TGn Sync Response to Questions

Date: **2005-03-16**

Author				
Name	**Company**	**Address**	**Phone**	**Email**
Syed Aon Mujtaba	Agere Systems	555 Union Blvd., Allentown, PA 18109, USA	+1 610 712 6616	mujtaba@agere.com

Benefits of TGn Sync Extended MCS set (from presentation)

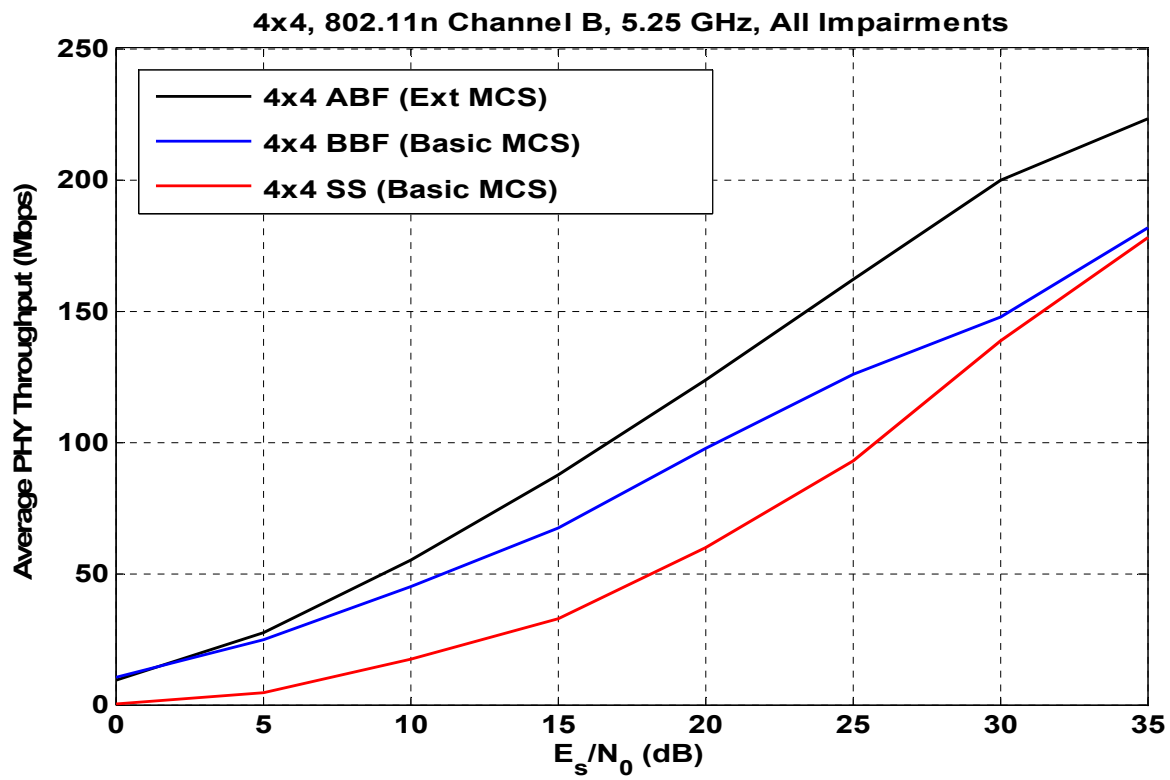
WWiSE – Q3

In ABF, instead of having, for example, {256-QAM, 256-QAM, 256-QAM, QPSK}, why not just use 3 spatial streams if the streams are that different in quality?

Tx BF is superior to STBC

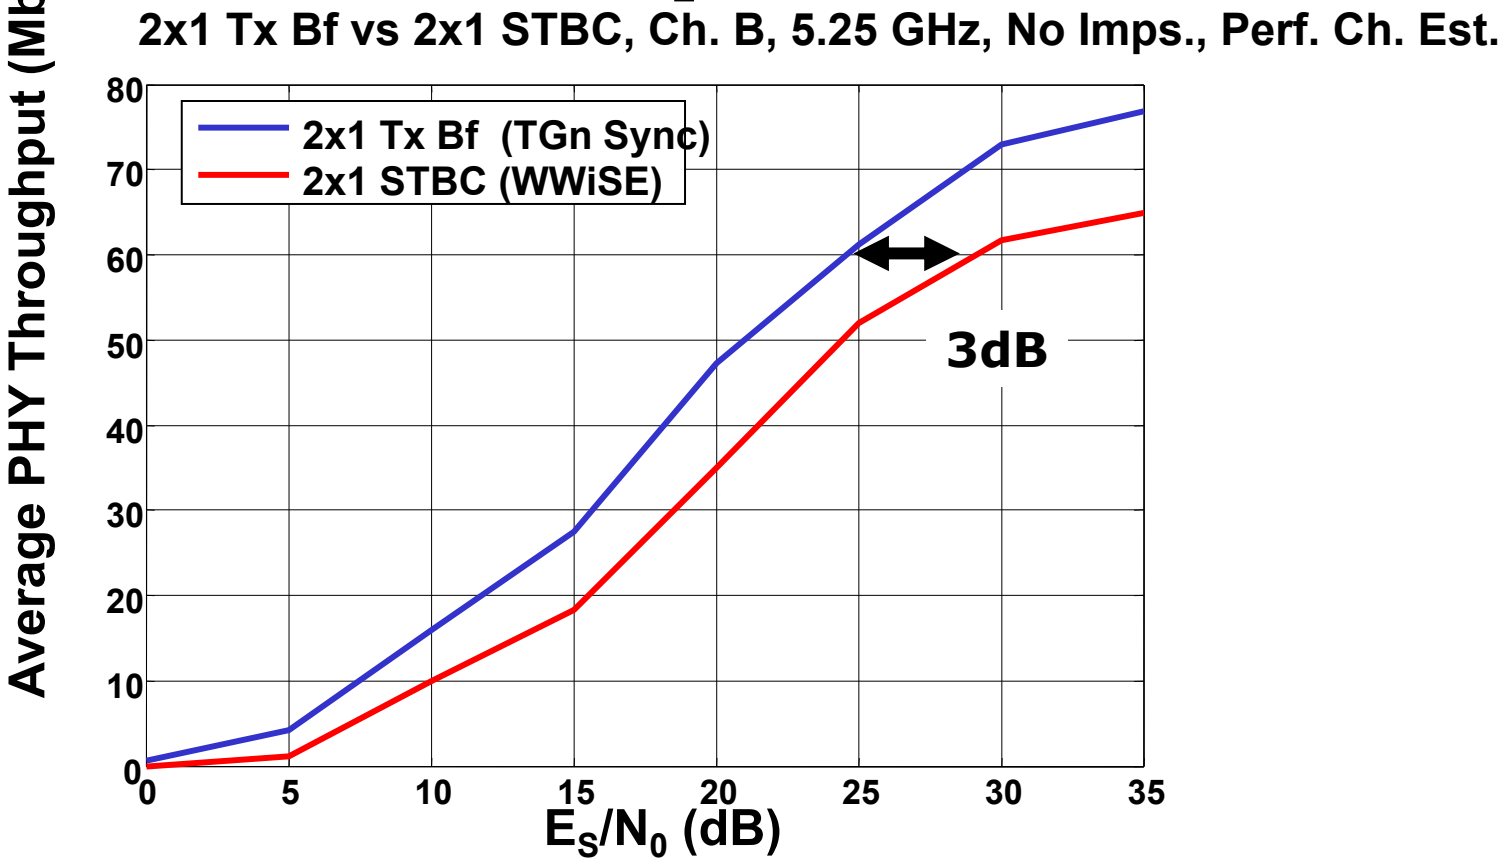
Why are space-time block codes missing from the proposal?

- Is there any technical reason why these have been omitted?

- Simplicity, not needed since TxBf outperforms it. Additional complexity of 2-symbol processing, overhead ofextra dead symbol etc.

➡ Also complexity of dual symbol processing, more modes etc.
